FINAL DRAINAGE REPORT

**LOT 2 ELM GROVE VILLA SUBDIVISION
SMITH PLUMBING & HEATING
PCD Filing No.: PPR2143**

PCD Filing No. PPR2143

DETENTION BASIN STAGE-STORAGE TABLE BUILDER

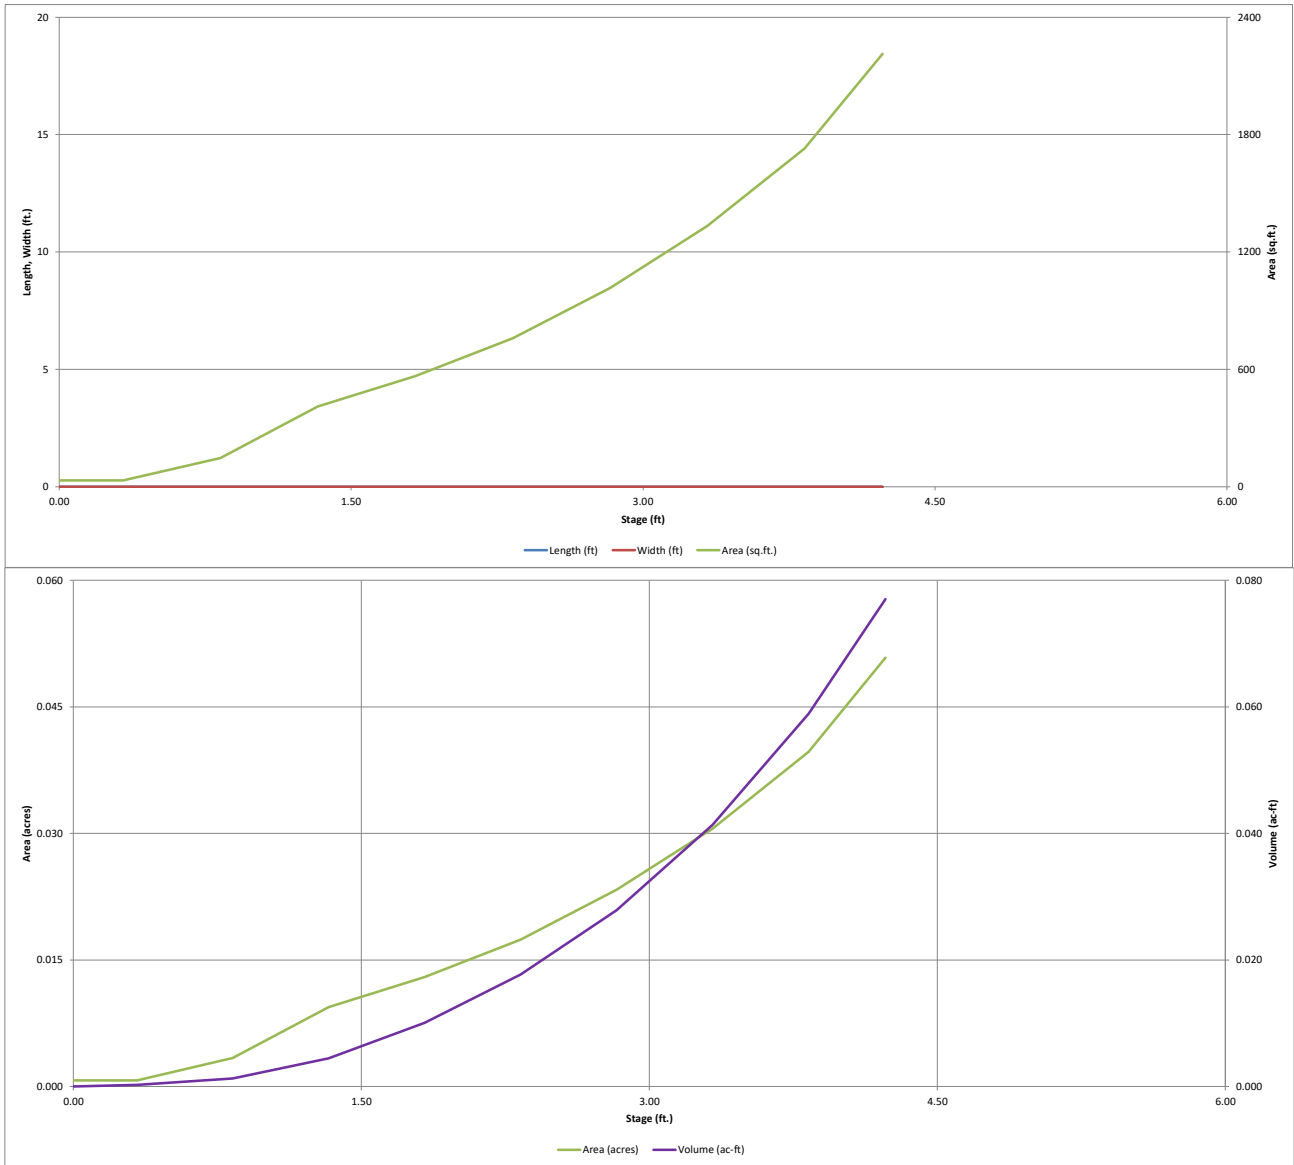
If this what you are trying to use to show Runoff Reduction, it is not sufficient. Please go to MHPD's website and subsequent Software page and use their latest UD-BMP spreadsheet (v3.07). See "Runoff Reduction" tab on that spreadsheet.

RUNOFF REDUCTION SPREADSHEET ADDED FOR SUB-BASIN E-6 WHICH IS NOT ROUTED TO THE POND AND PROVIDES ITS OWN WQ

WQ PLAN

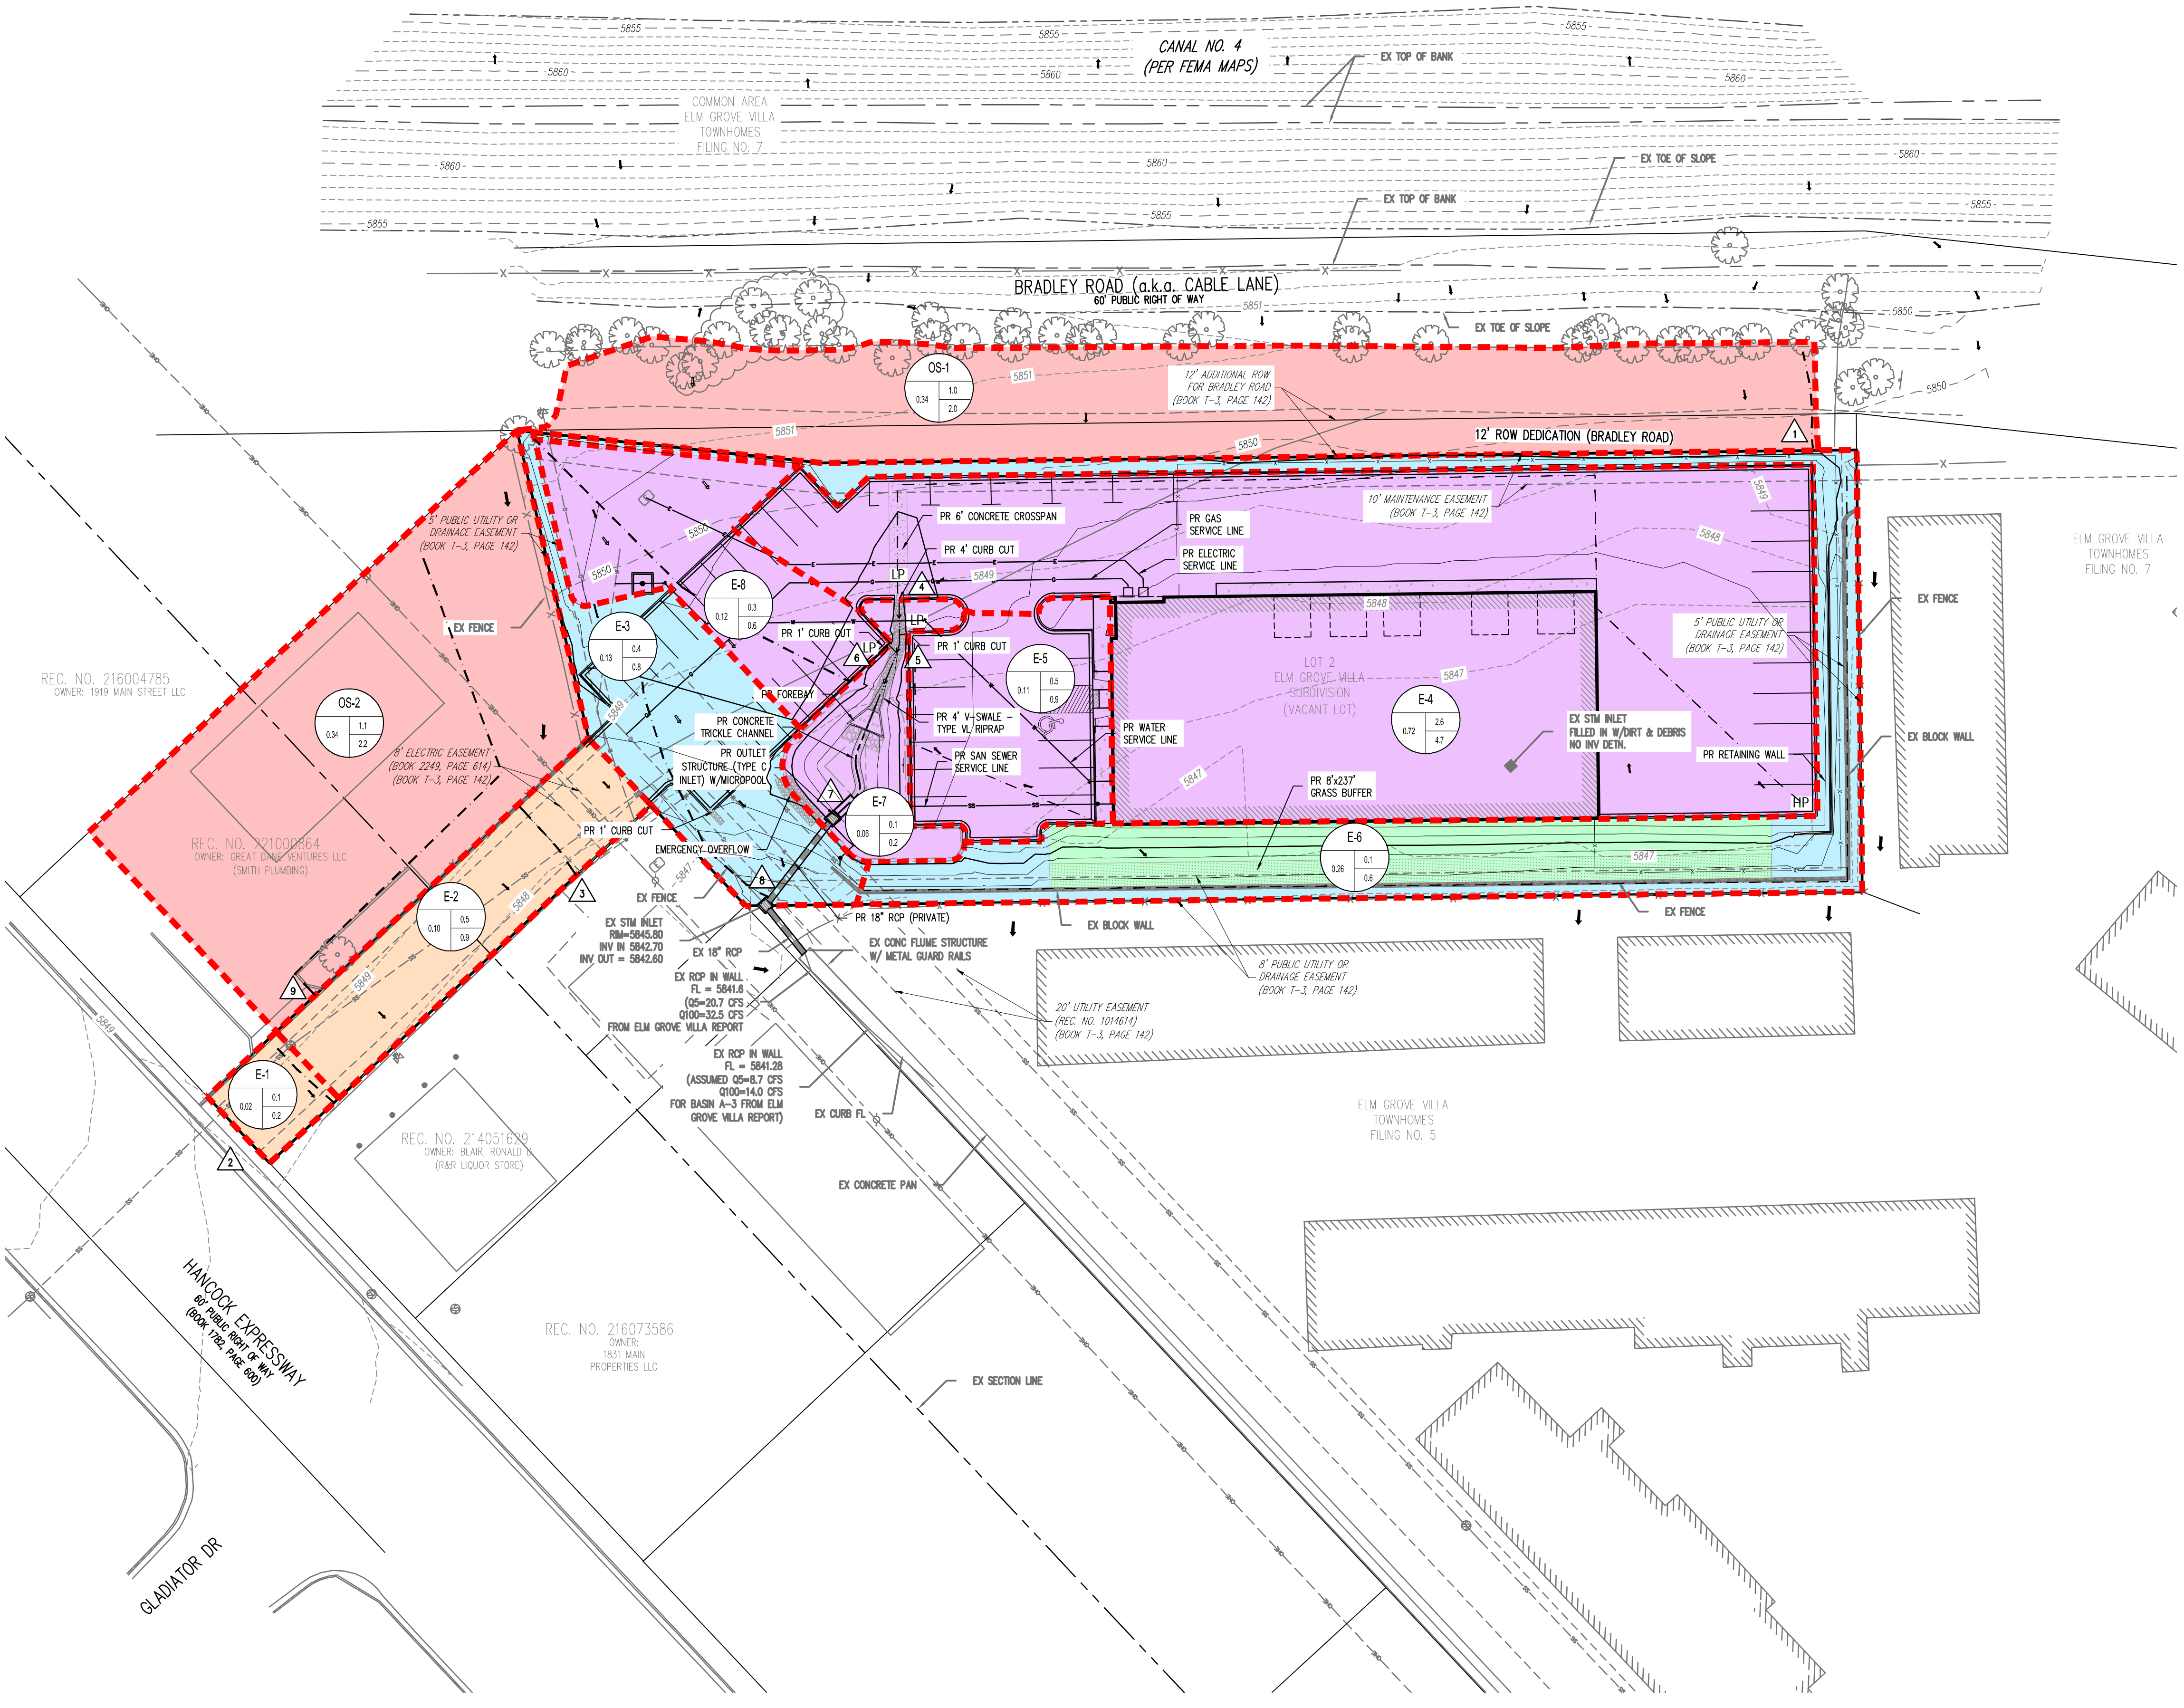
From field observations, the flow exiting the 6' concrete pan is not directed or funneled sufficiently to the curb chase. A suitable conveyance should be implemented to direct flow to concrete chase. See pdf pg 25 below.
